September 19, 2022

**RE: Drainage Letter Report Solace Apartments – Revision Request
El Paso County, CO**

Please make sure the project name matches the final plat title

Engineering Profile - ST-F (Cimarron Hills Phase II.stsw)

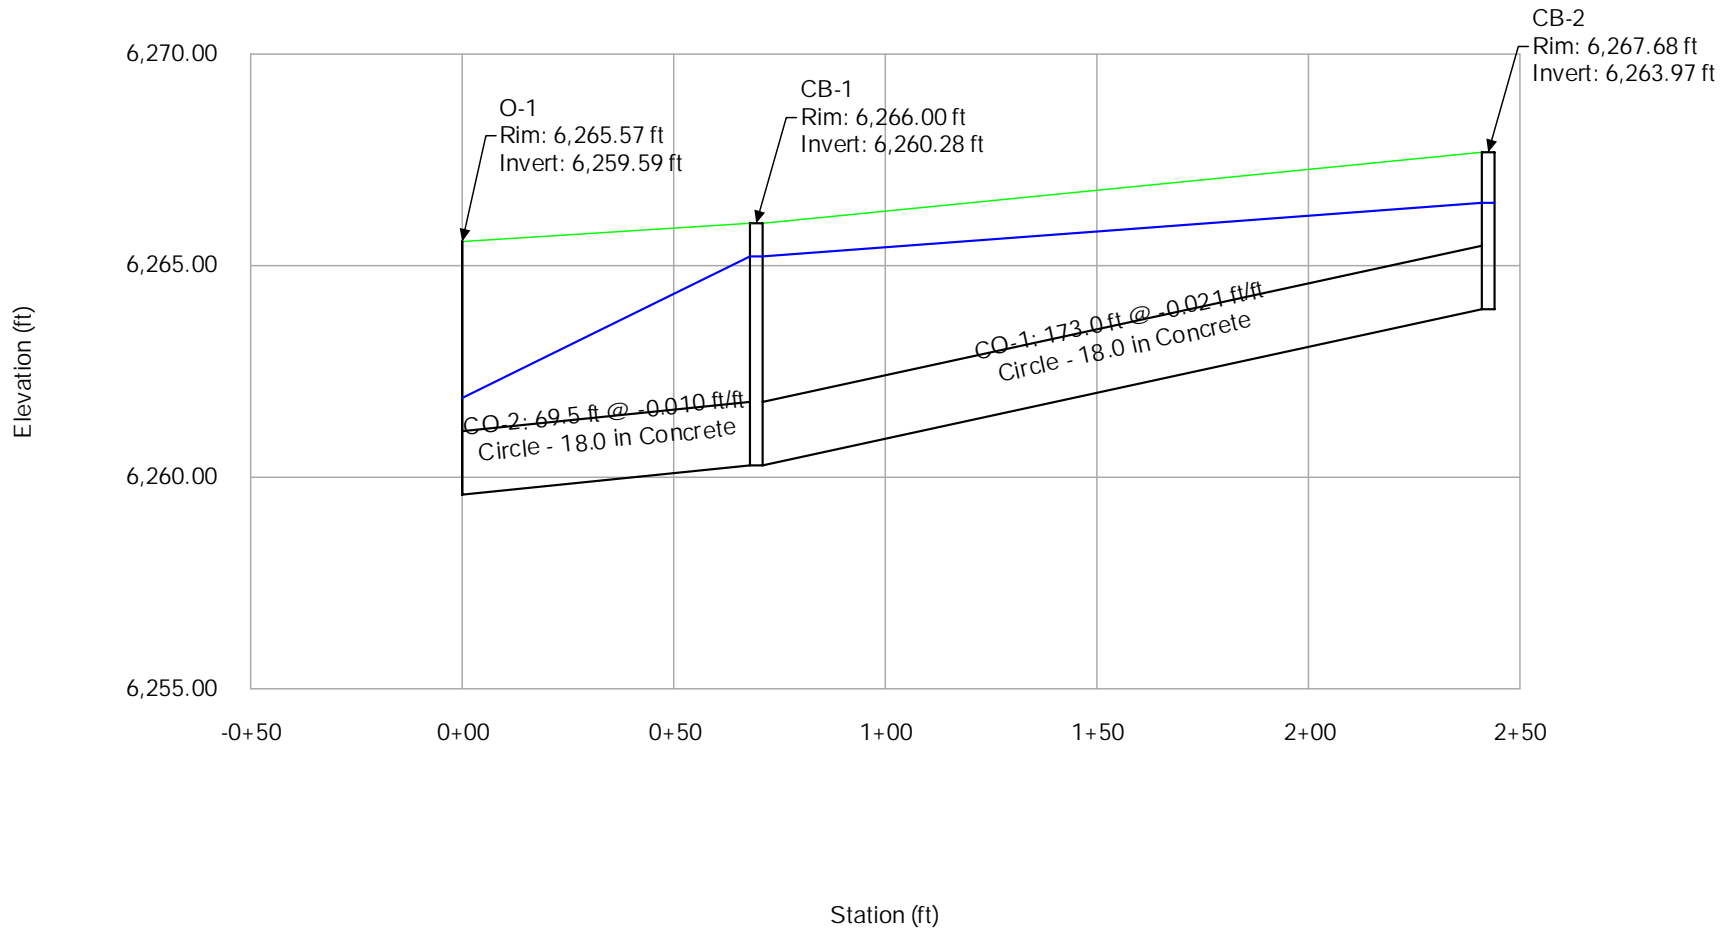
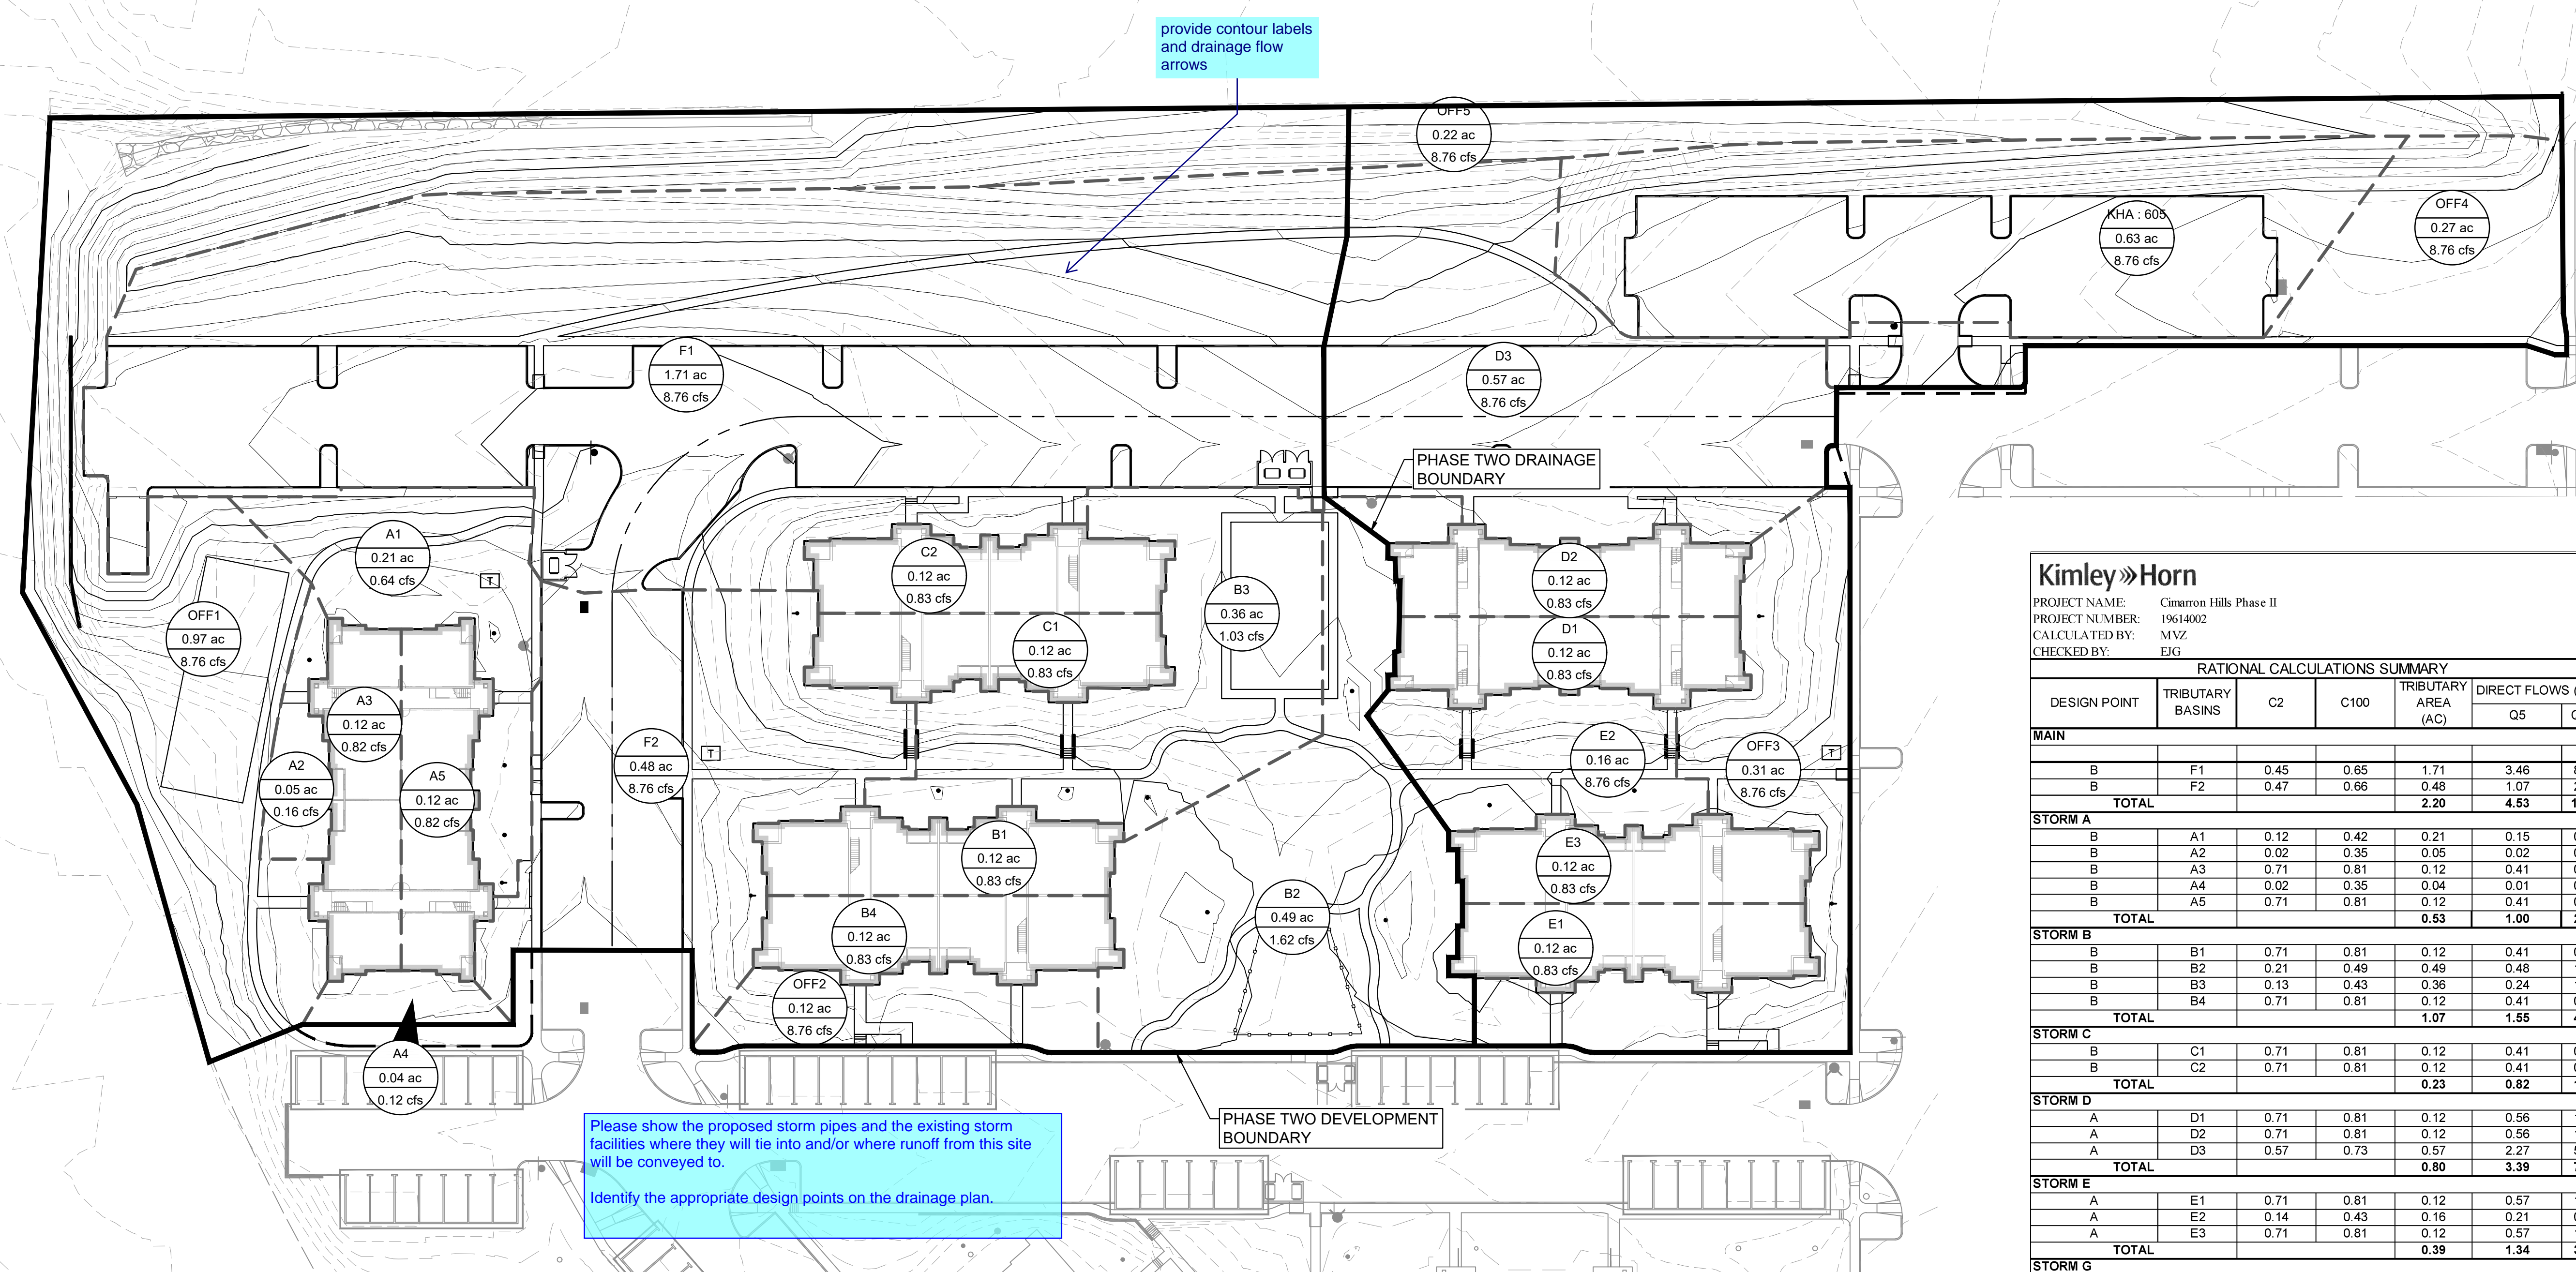
Per the CD's ST-F storm pipe indicates that the HGL is not within the pipe. Be sure to specify water tight joints where pressure pipe conditions occur. Revise the statement accordingly.

the table on the drainage plan identifies storm A through E and G. As the storm pipes are not shown on the drainage plan it is not clear what is proposed or what is existing. Please see comments on the drainage plan and identify the existing and proposed storm facilities.

provide contour labels and drainage flow arrows

Please show the proposed storm pipes and the existing storm facilities where they will tie into and/or where runoff from this site will be conveyed to.

Identify the appropriate design points on the drainage plan.
